Department of Environmental Quality

Re: WQ: Variance Approval: 248-25-000016-VAR: 4047 SW Wickiup Court; T.15S; R.13E; Sec. 19DC; Tax Lot 1100; 0.46 Acres; Deschutes County.

**Schedule A – Sweet
Variance Report - Special Conditions
T 15S, R 13E, Sec: 19DC, TL 1100**

SUBJECT: Formal Variance Request – Greg Sweet – T15S, R13E, Section 19DC, Tax Lot 1100 (0.46 acres), Deschutes County, West of Redmond, Oregon.

Figure 3A. Modified Bottomless Sand Filter Section – Initial

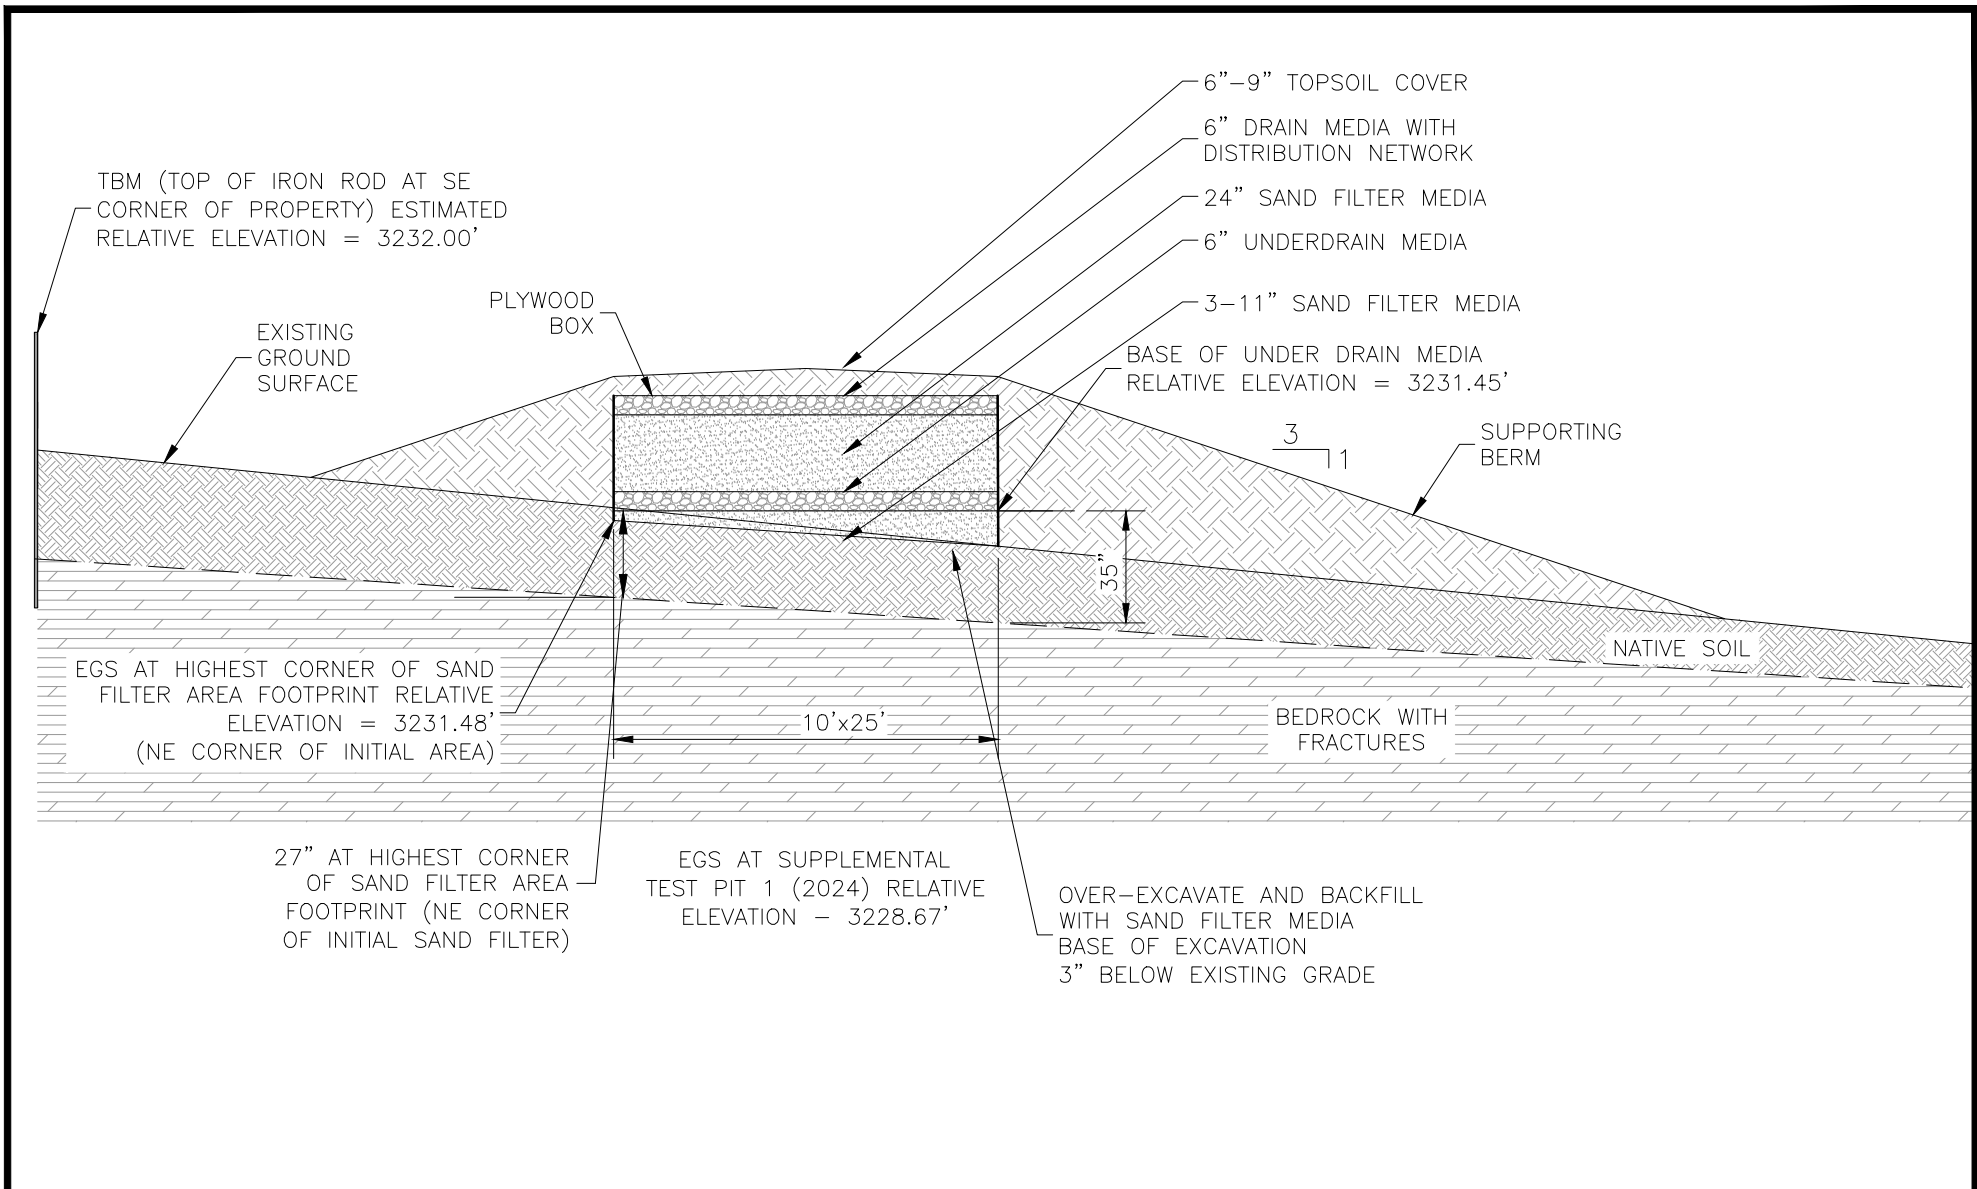
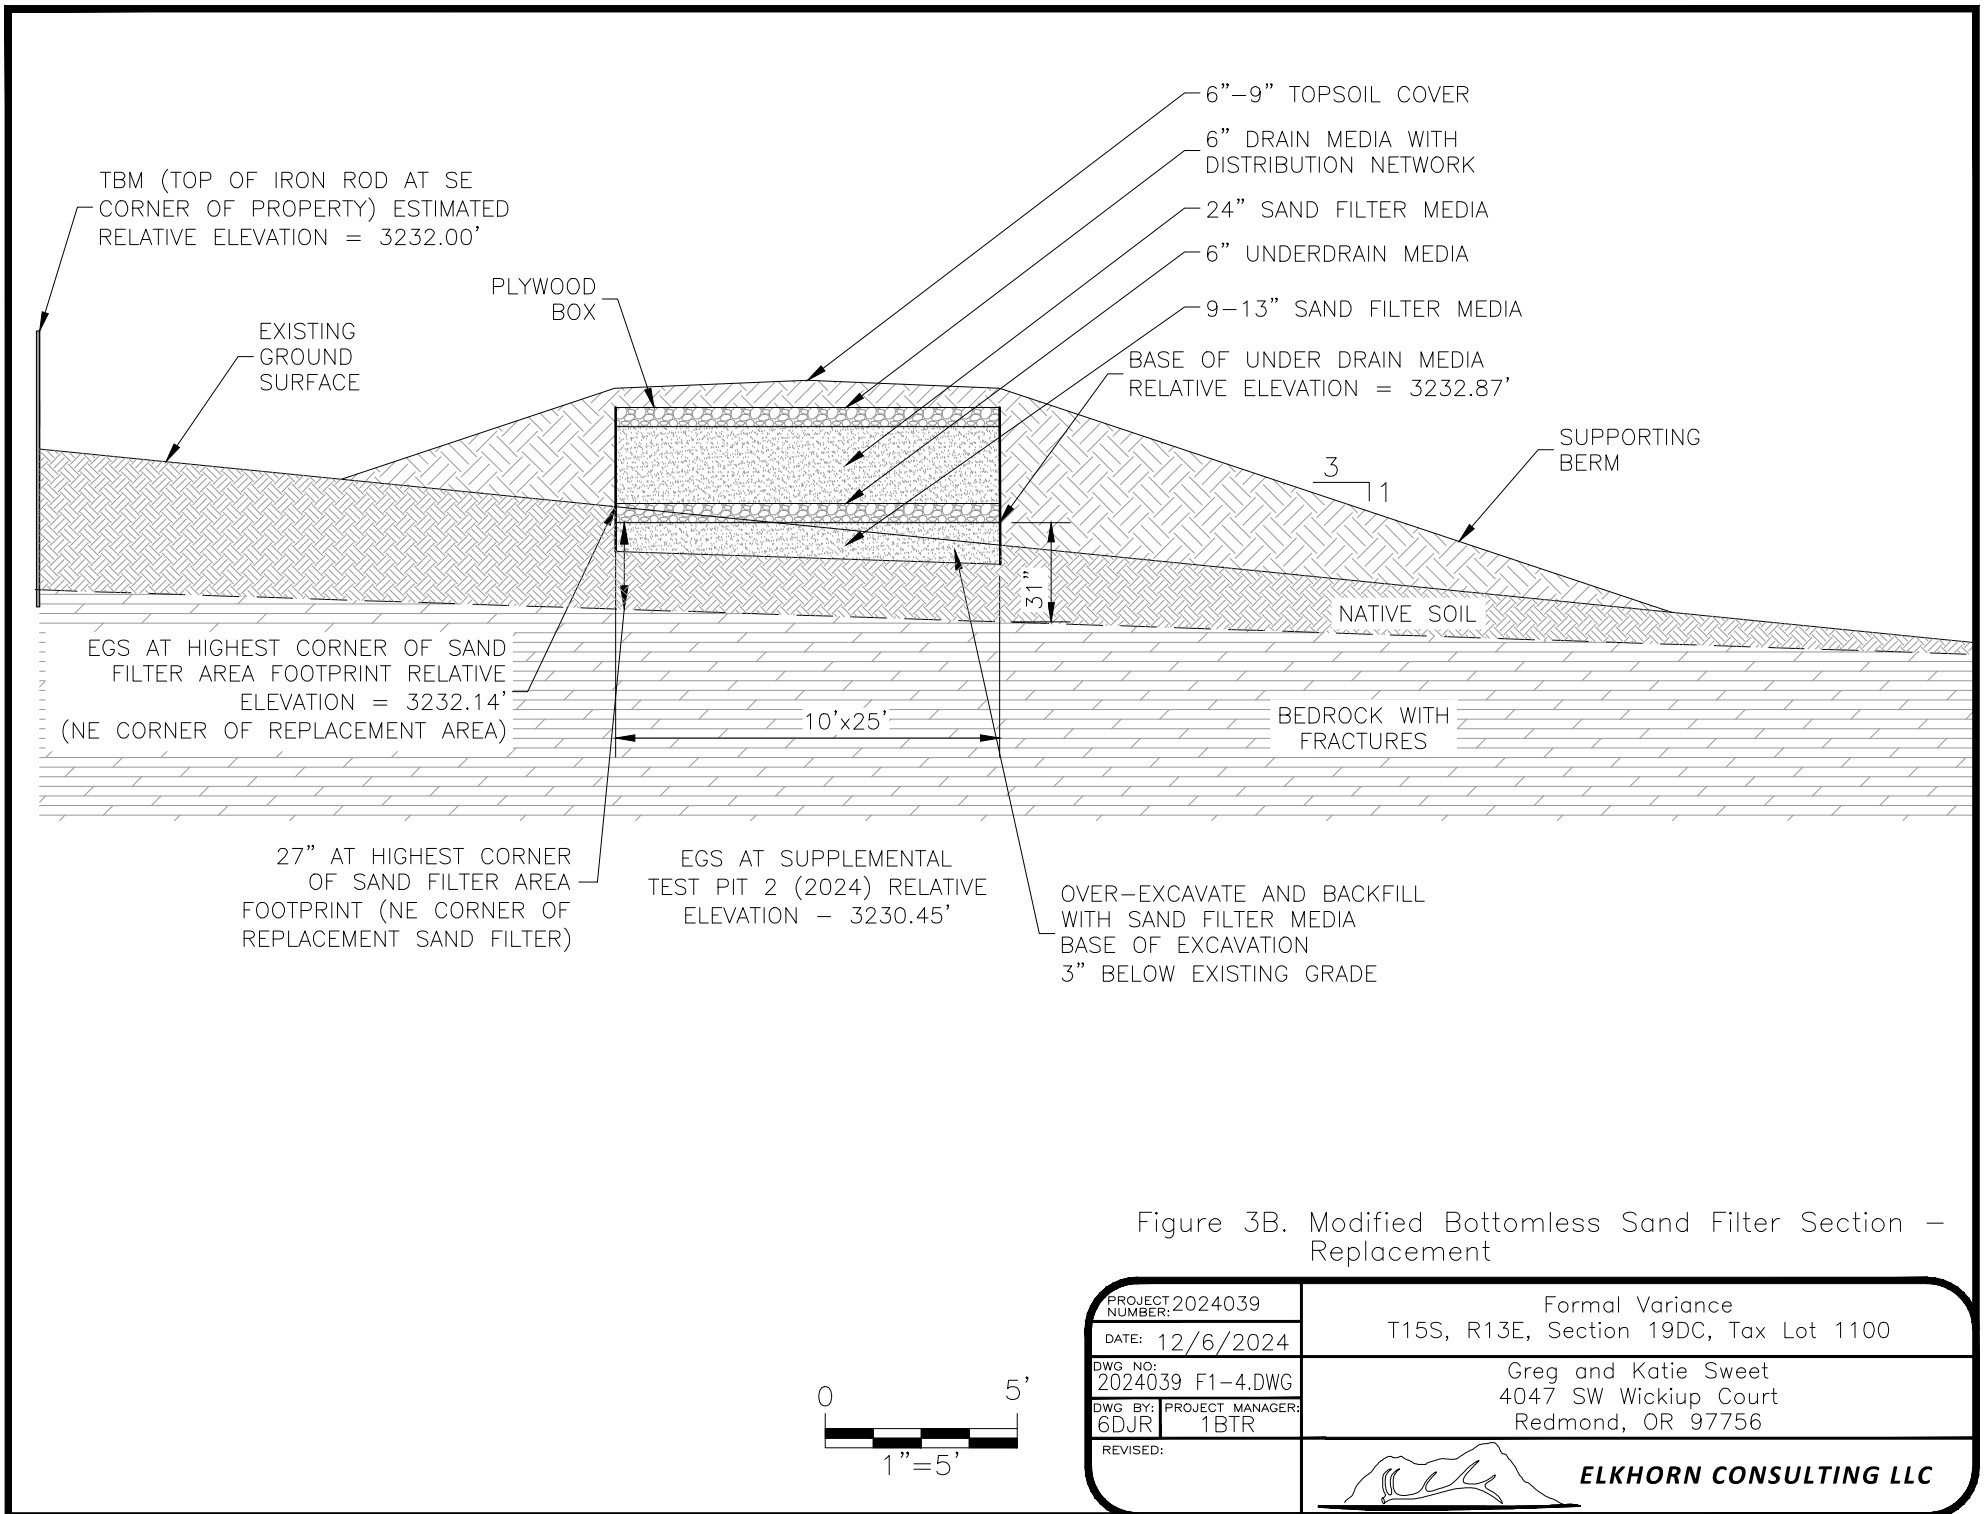
The proposed solution to overcome site limitations involves installing an Orenco® AdvanTex AX20N-Mode 3B Alternative Treatment Technology System, which will discharge to a 250 sq. ft. elevated Bottomless Sand Filter. This filter will be constructed on an 8- to 14-inch bed of sand media embedded 3

inches into the native soil. The proposal addresses the 2-foot continuous soil limitation by adding the 8 to 14 inches of additional sand media, thereby providing a total vertical separation of 31 to 35 inches from the bottom of the system to the shallowest depth of bedrock. The rest of the sand filter will be “conventional” from there up, consisting of 6 inches of underdrain media, 24- inches of sand filter media, 6- inches of drain media (with the distribution laterals), filter fabric, and 6-9 inches deep of final backfill on top. The sand filter will be contained within a supporting berm with a slope no steeper than 3:1.
